SERVICE BULLETIN

PURPOSE : INFORMATION	ISSUE NO. : MSB-12EXML42-002A	DATE : 2013-1-21
SUBJECT : ADJUSTMENT OF DOOR STRIKER FOR THE VEHICLES WITH SIDE AIRBAGS(built-in by a seat) AND CURTAIN AIRBAGS	<Destination/Model> <M/Y> (ALL DESTINATIONS) ALL	
GROUP : BODY	ALL MODELS WITH SIDE AIRBAGS(BUILT-IN BY A SEAT) AND CURTAIN AIRBAGS

42A-55

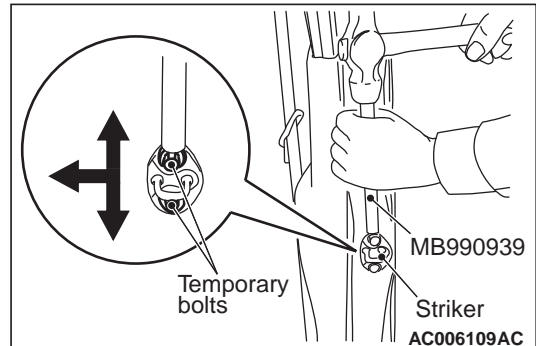
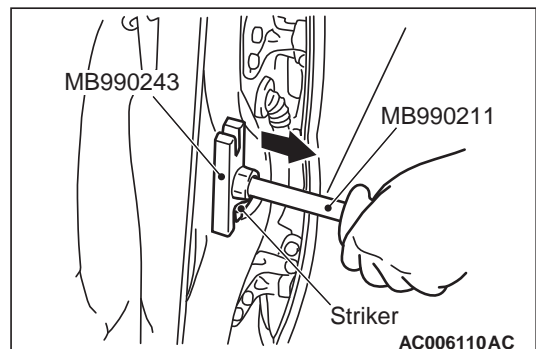
<Added>

CAUTION

To adjust the striker, always turn the ignition switch to "LOCK" (OFF).
